Technical Service Information

FORD 4EAT PROBE LOW PUMP PRESSURE

Figure 1

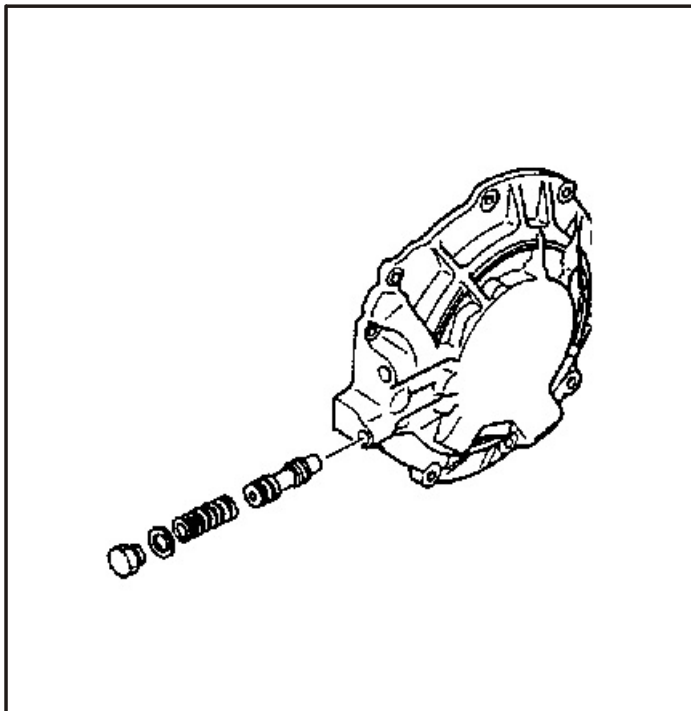
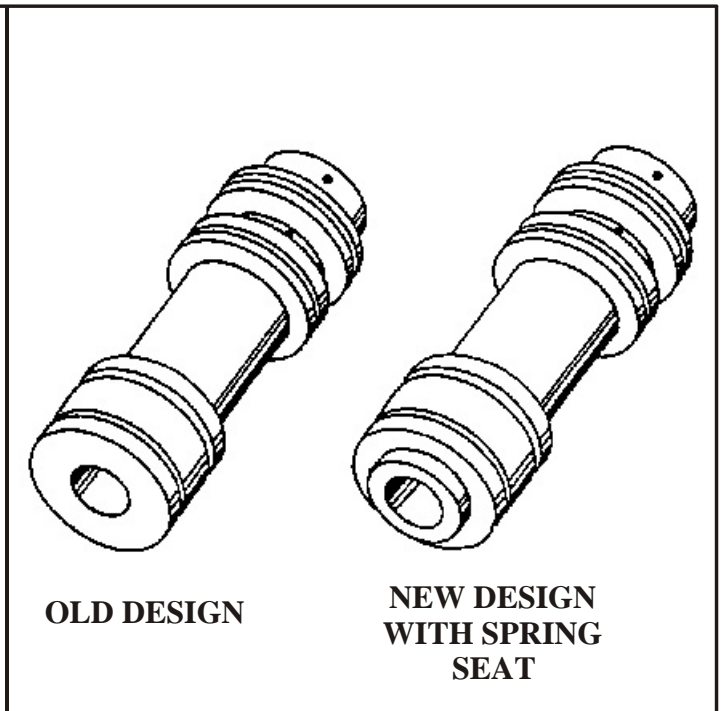
COMPLAINT: Low pump pressure.

CAUSE: The spool valve in the pump did not have a seat for the spring. The spring will hang the valve and cause low line pressure (figure 1).

CORRECTION: Order updated valve from Ford. It has a seat formed on the valve for the spring and will work on both units (figure 2) part # FO2Z-7Z306-A.
